SOUTH CAROLINA ELECTRIC & GAS COMPANY

July 10, 1981

Subject: Virgil C. Summer Nuclear Station  
Docket No. 50/395  
SER Item 1.7.21  
Seismic Qualification of Equipment

# Modal Analysis of Summer Plant SIS Accumulator Tank

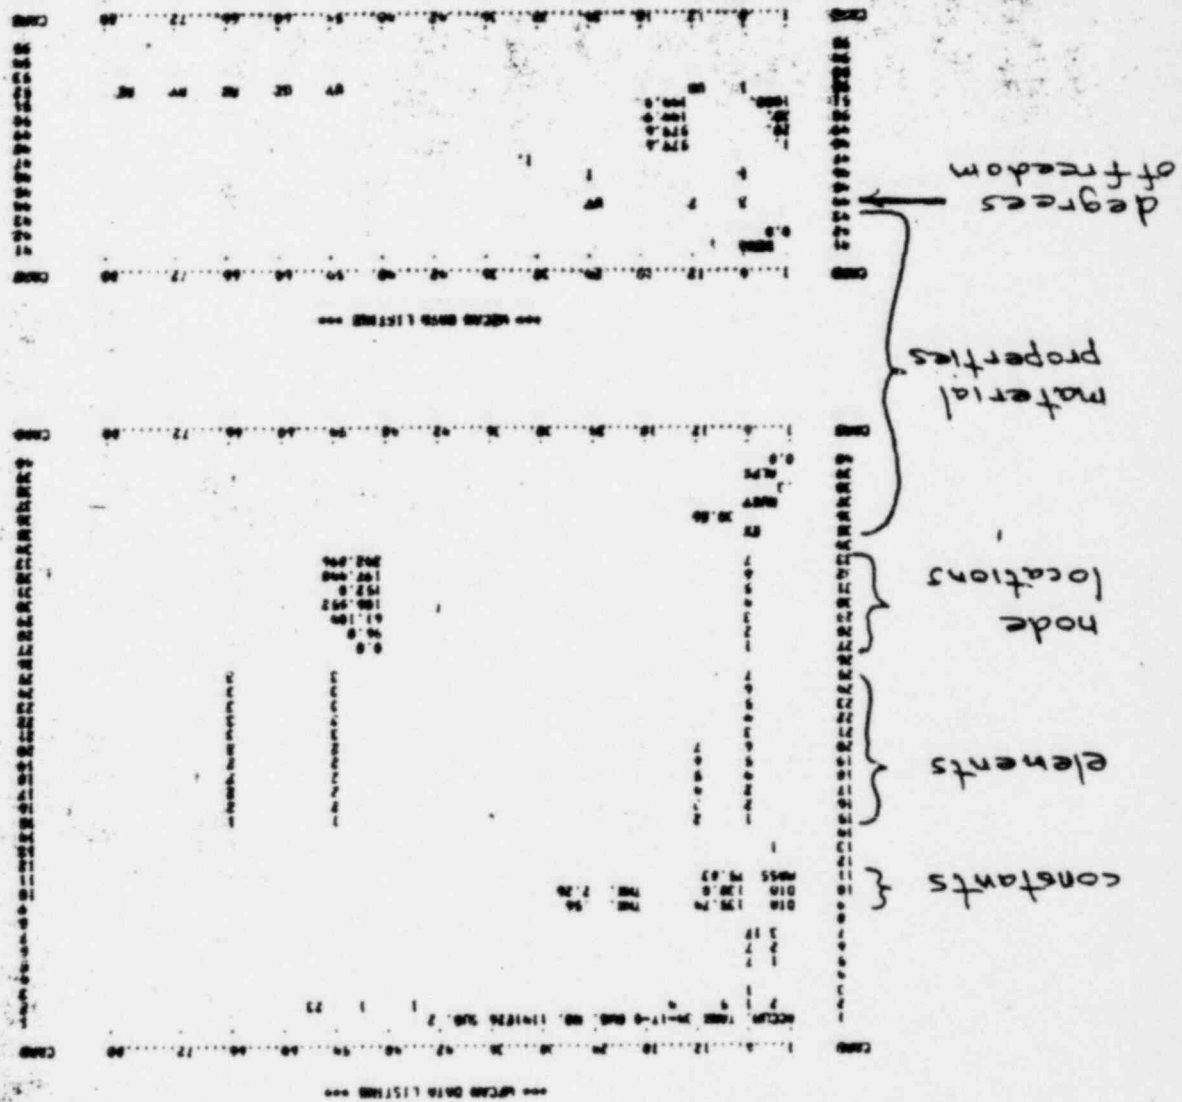
1. The computer input and output for the modal analysis performed by Westinghouse was not available at the meeting.
2. There was no one document which tied together all the analyses and reports used to demonstrate qualification of the Virgil C. Summer accumulators.

In order to resolve these concerns Westinghouse has initiated the actions described below which were deemed acceptable by the NRC consultant. Relative to the first concern, a simplified model of the modal analysis is provided in Attachment B and the computer input and output for the modal analysis is provided in Attachment C. Relative to the second concern, Westinghouse has revised Calculation Note 34-17-1 to contain a summary statement identifying the analyses and reports used to demonstrate seismic qualification of the Virgil C. Summer Nuclear Station accumulators. The summary information contained in the calculation note is similar to the information described on the second page of Attachment A.
